Eleska House

58 Dale Street
Manchester,
M1 2HN

April 2020

Responses are marked in RED.

Diagram from the manufacture Pilkington showing parts and specification of the glazing pane

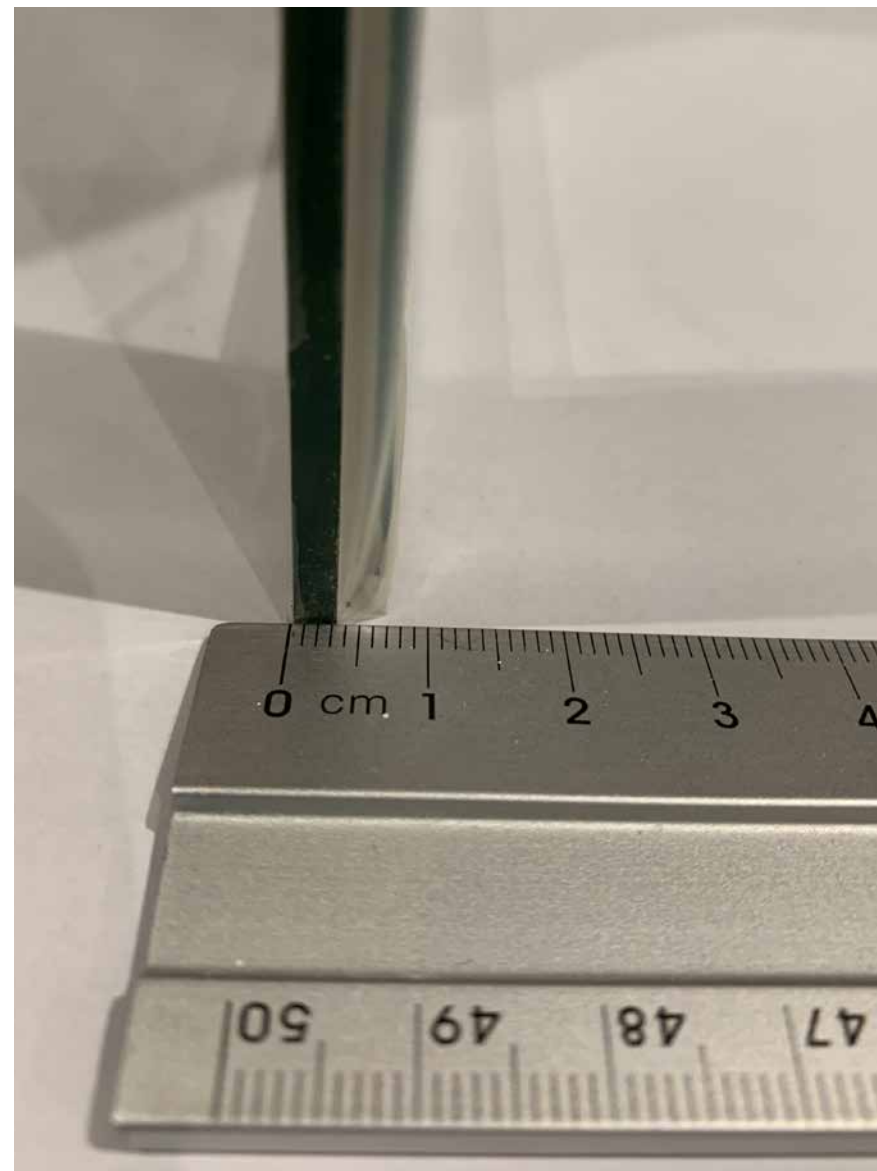
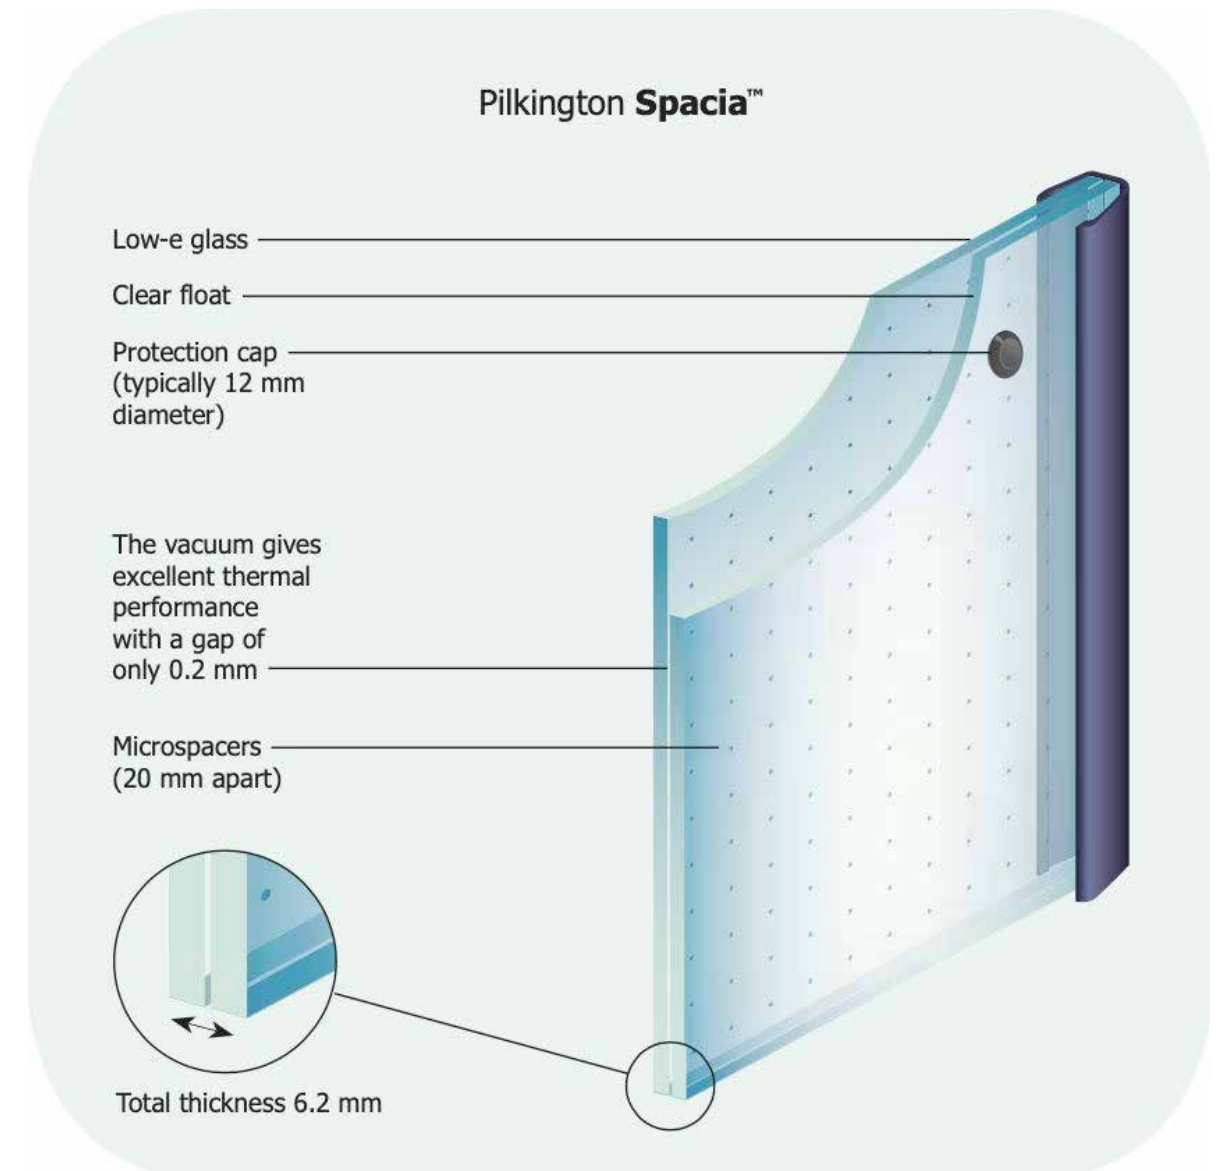
a) Details of the new external glazing, including a sample.

Sample piece of Pilkington Spacia glazing showing the 20mm microspacers and glazing pane 12mm protection cap

Sample piece of Pilkington Spacia glazing showing the 6mm thickness overall

LOADING BAY SECTION A_A

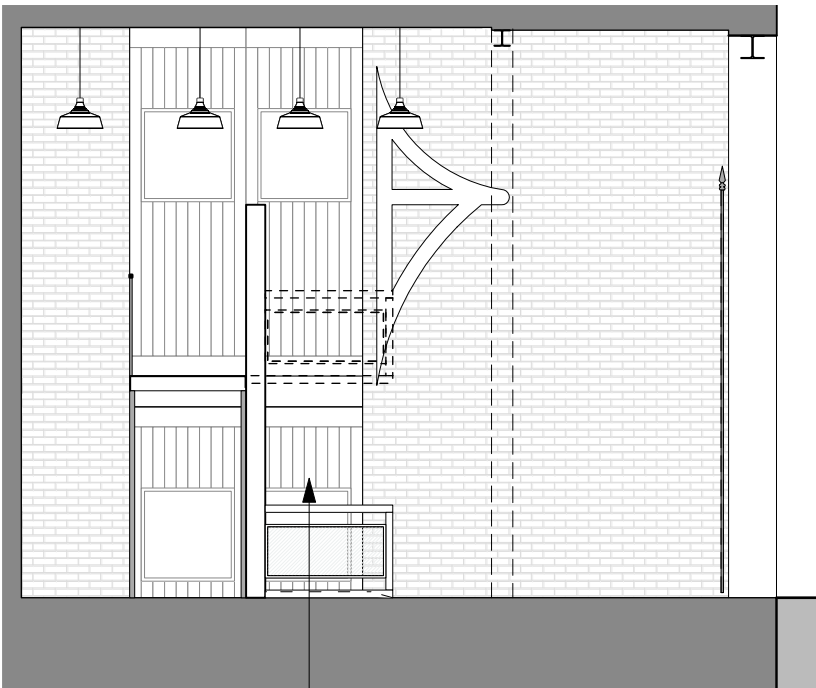
b) the proposed basement/ground level new lift

The proposed Gartec 3000 Platform Steo Lift does not require a pit to be created, instead an integrated ramp can be provided to raise the platform slightly, allowing it to operate without a pit. The lift will be secured to non-original steel posts of the remains from the existing steel stairs.

Gartec 3000 Platform Step Lift with integrated ramp which prevents the need for a pit. Lift will be secured to non-original steel posts of the remains from the existing steel stairs

Typical Wall Details
Further details can be obtained from: <https://www.british-gypsum.com/>

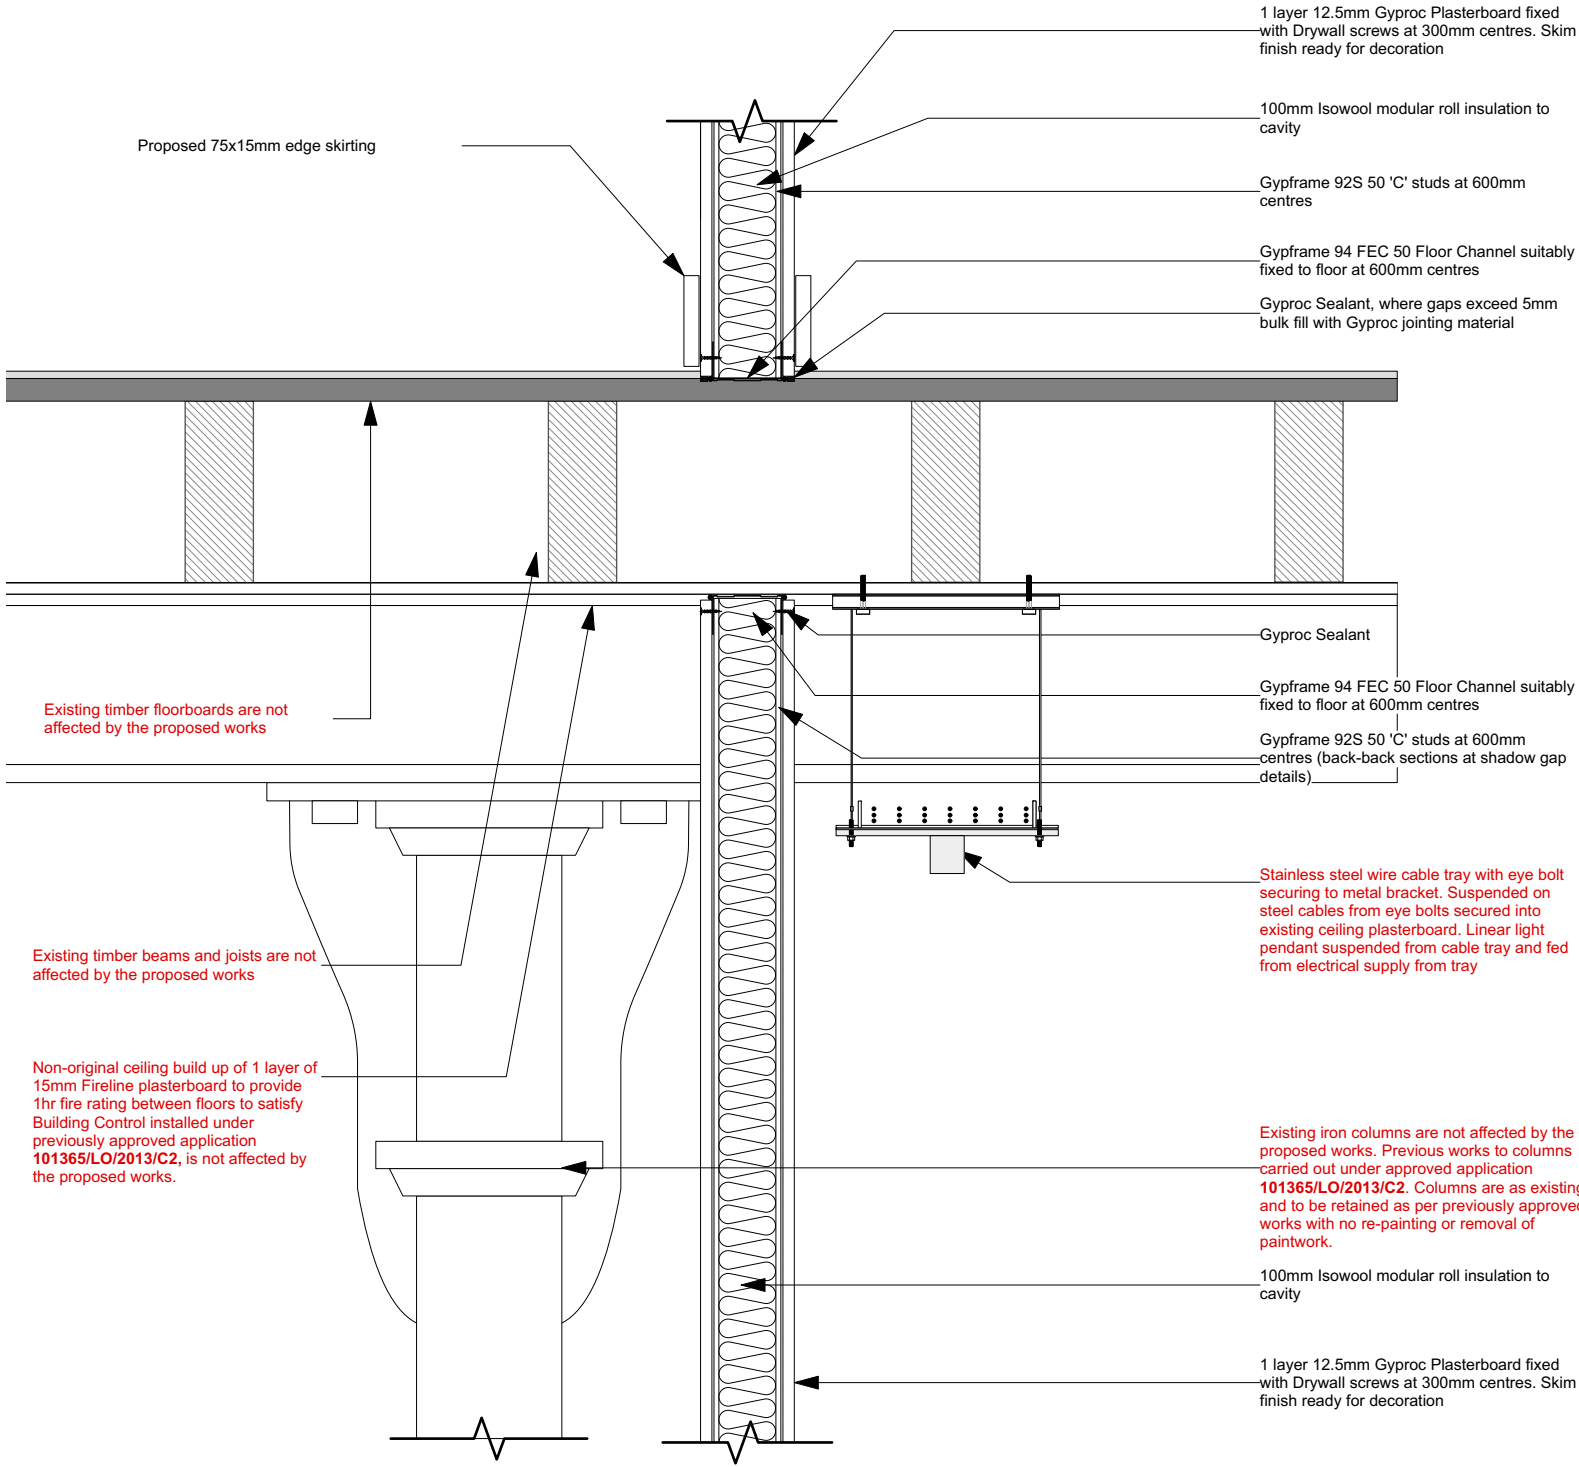
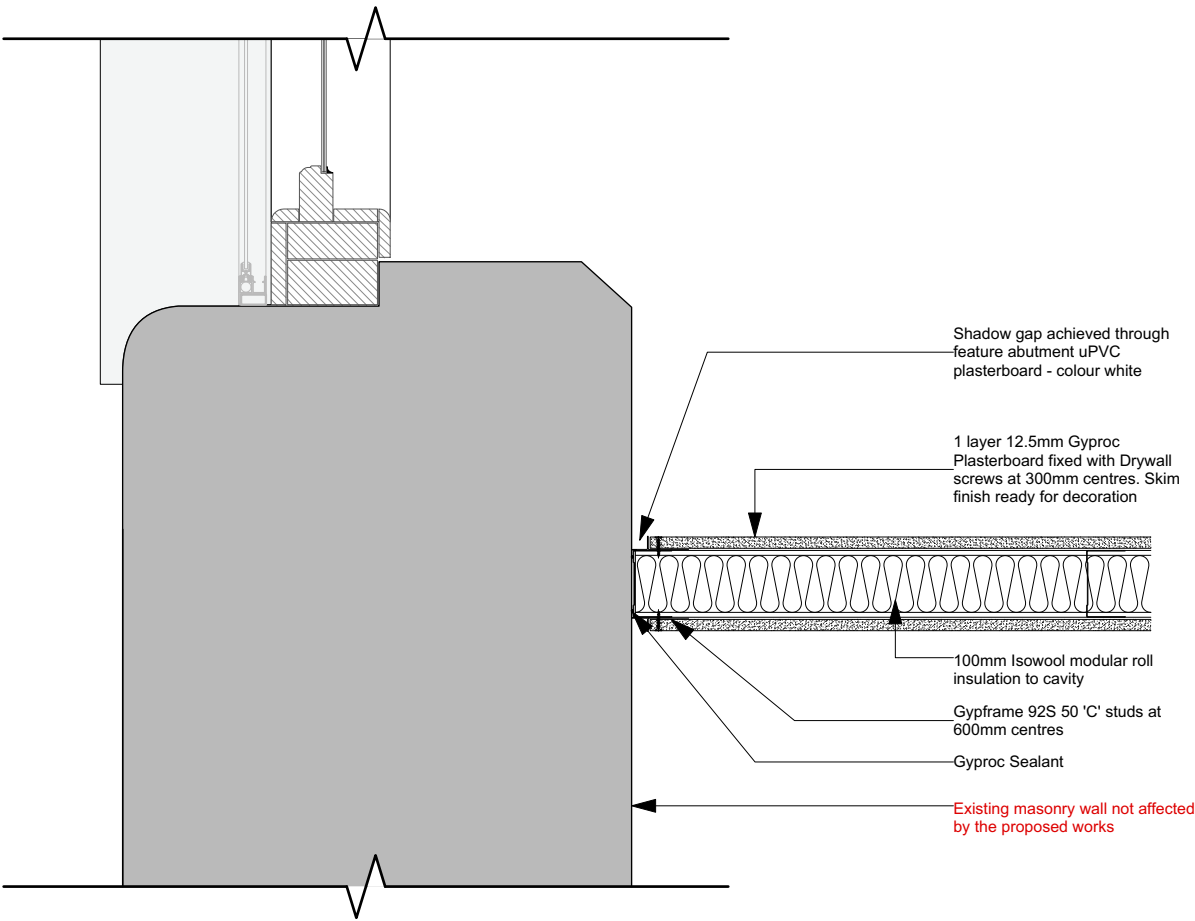
c) Details of a trail sample of cleaning to paintwork.

e) Details of existing internal Iron Column paint colour.

No cleaning to paintwork will take place. Previously suggested cleaning to underside of floorboards and timber beams & joists will not take place due to the works previously carried out under approved application 101365/LO/2013/C2. As such, these areas are not affected by the proposed works and will be retained as part of the proposed scheme.

Drawings 403 & 404 have been updated to confirm the proposed works won't affect the floorboards and timber beams & joists.

No cleaning to paintwork will take place. Previously suggested cleaning to iron columns will not take place due to the works previously carried out under approved application 101365/LO/2013/C2. As such, these areas are not affected by the proposed works and will be retained as part of the proposed scheme.

Drawings 403 & 404 have been updated to confirm the proposed works won't affect the iron columns
